Projecting Eaves Section detail

Project: Extension: 21 Bank Buildings, High Street, Belper. DE56 1GF		
Client: M.Cooper		
Drawing Title: 1:5 Detailed Sections		
Scale: 1:5 @ A3	Origin Date: Dec '19	Drawn: D.Guy
Job No: C1065	Drg No: 2023/Z/03	Revision: 0

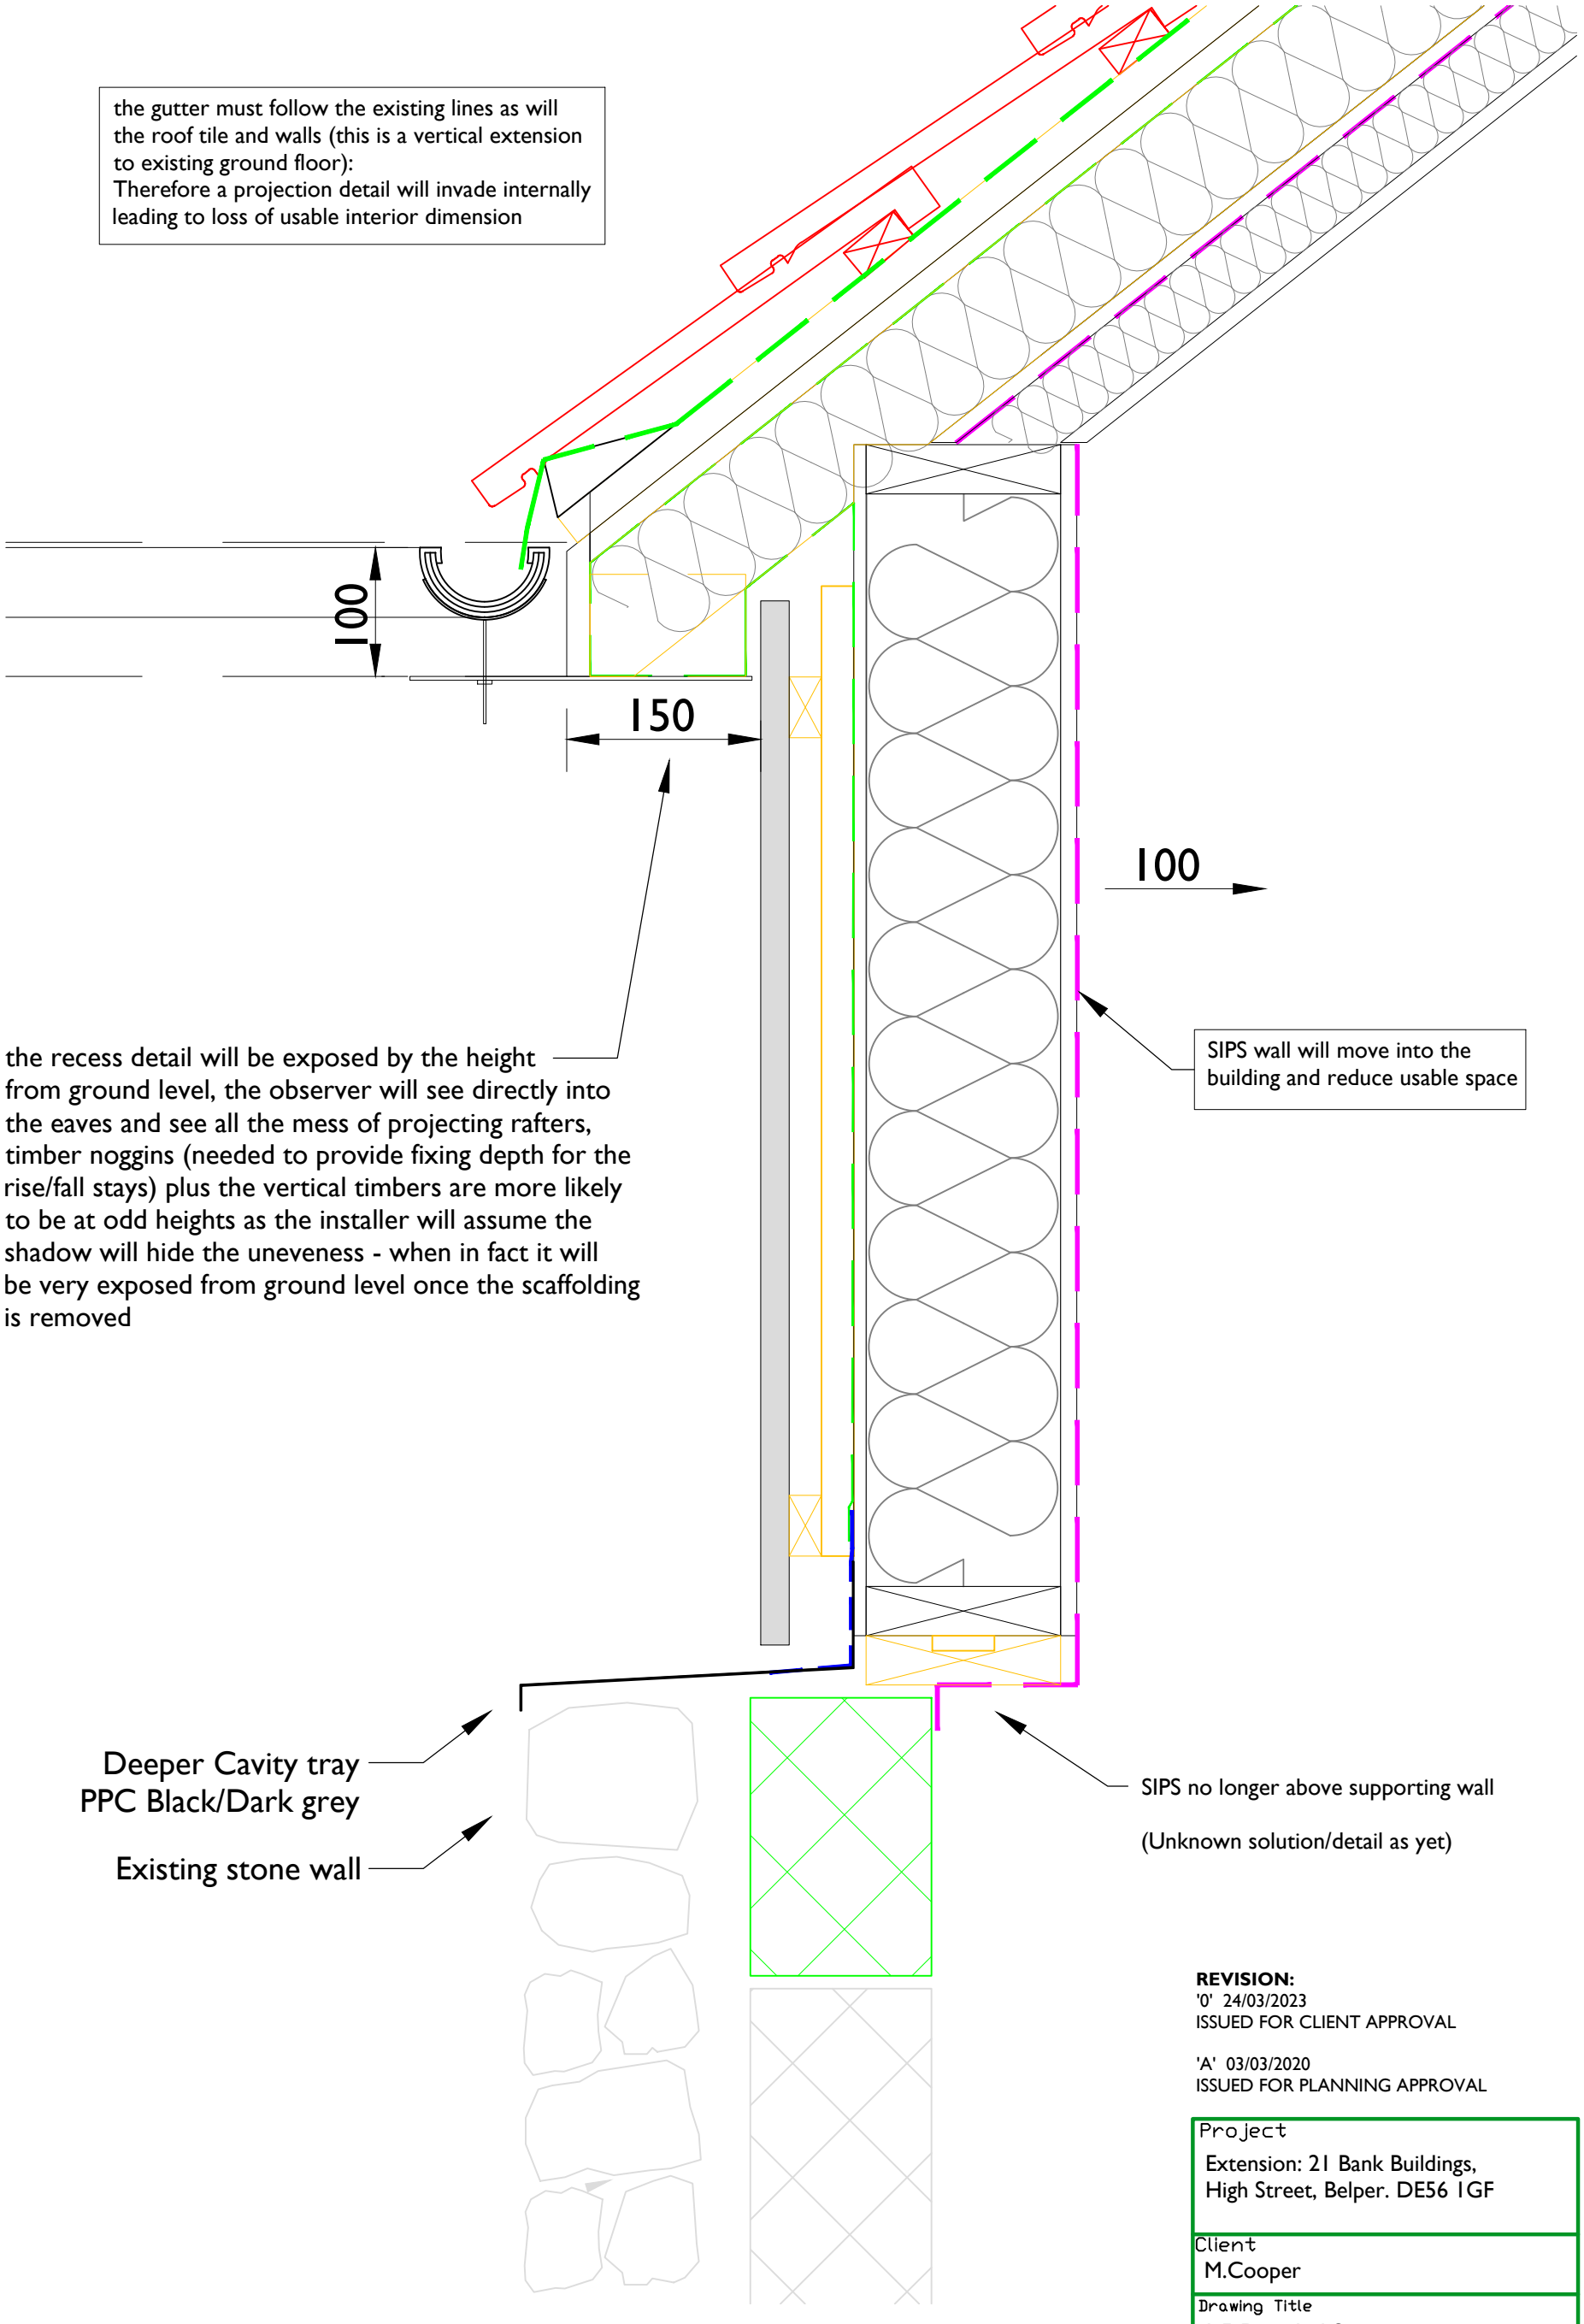
the gutter must follow the existing lines as will the roof tile and walls (this is a vertical extension to existing ground floor):
Therefore a projection detail will invade internally leading to loss of usable interior dimension
